SUBJECT: Forwards suppl to 791231 response to Lessons Learned Task Force short-term requirements.

H. B. ROBINSON STEAM ELECTRIC PLANT UNIT NO. 2  
DOCKET NO. 50-261  
LICENSE NO. DPR-23  
LESSONS LEARNED SHORT TERM REQUIREMENTS

Additional Information Concerning  
IMPLEMENTATION OF SHORT TERM LESSONS LEARNED ITEMS AT  
H. B. ROBINSON

Attachment No. 1

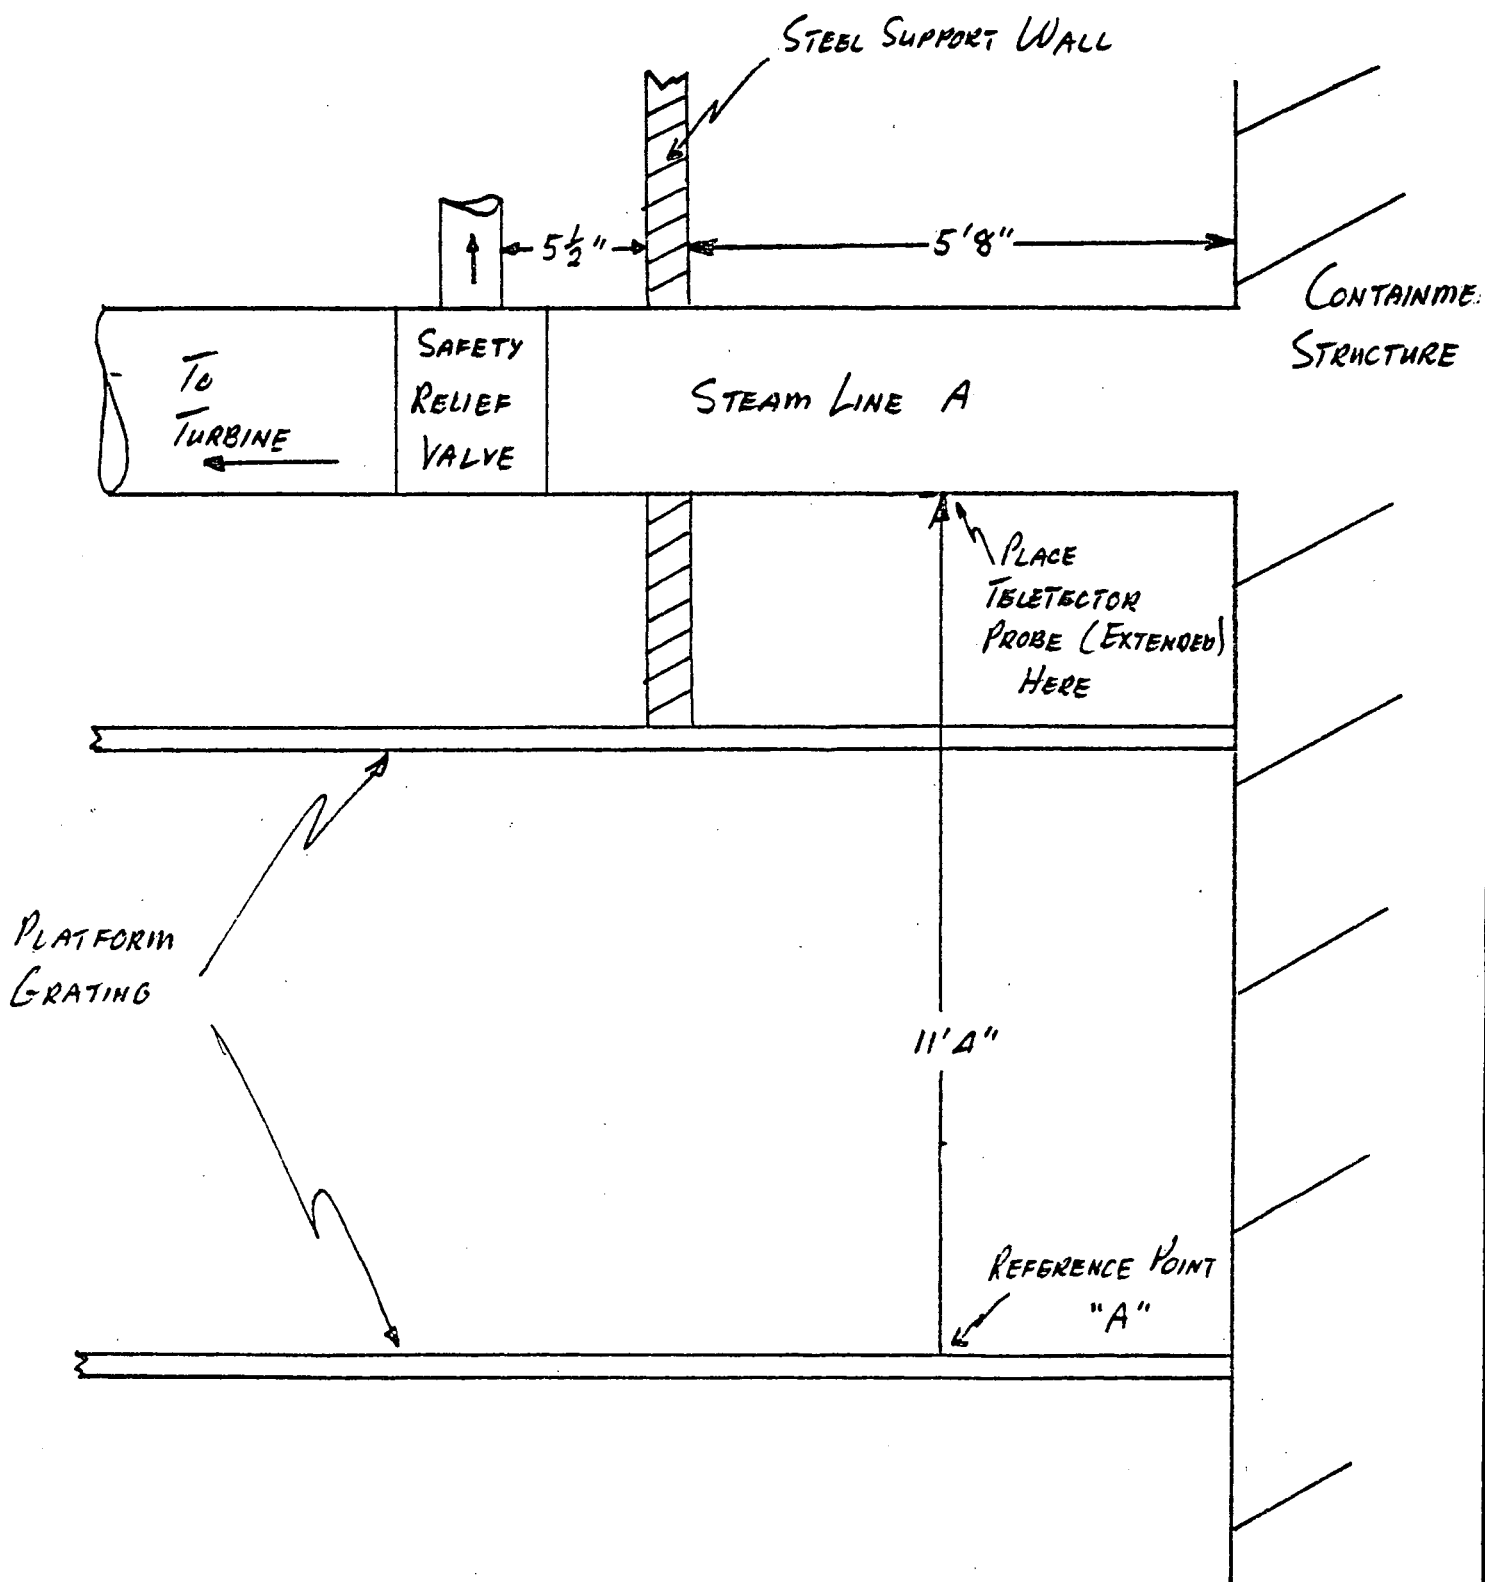
- Effluent Monitors
- A. Provide a real time method of measuring noble gas release from the steam reliefs.
  - B. Document the range of noble gas monitors.
  - C. Provide a description of methods for measuring Iodine and particulates.

- A. An interim method for providing real time measurements of noble gas releases from the steam reliefs has been developed. The basis for determining effluent release rates (Ci/sec) through the relief valves combines the data collected from an Eberline Teletector Model 6112 held adjacent to a main steam line, and a series of curves to be developed for various primary to secondary leak rates and post LOCA source strength spectrums. The procedure is basically the following:

- 1. Indications of substantial core damage are confirmed ( $t = 0$  sec).
  - 2. Relief valves open and the time and duration of atmospheric steam release are noted.

- 3. An RC&T technician, using a teletector, proceeds to a location one level below the main steam lines as indicated by reference point A on Attachment No. 1. The teletector is extended approximately 11' and positioned adjacent to the low point of steam line A. The dose rate is noted and the procedure is repeated for steam lines B and C.

4. The RC&T technician relates to the control room operator the dose rate information and the time the measurements were taken.
5. The control room operator locates the appropriate post LOCA steam line activity concentration curve (u Ci/cc vs. m Rem/hr) based upon:
  - a. the most recent information on primary to secondary leak rates (i.e., latest steam generator blowdown sample analysis).
  - b. time after core damage.
6. Knowing the contact dose rate of each steam line (step no. 3) a determination of the activity concentration (u Ci/cc) in each steam line is made using the curves.
7. Knowing the rated flow rates of the relief valves (cc/sec), and the number of reliefs that have opened (visual inspection), the activity release rate is calculated as follows:
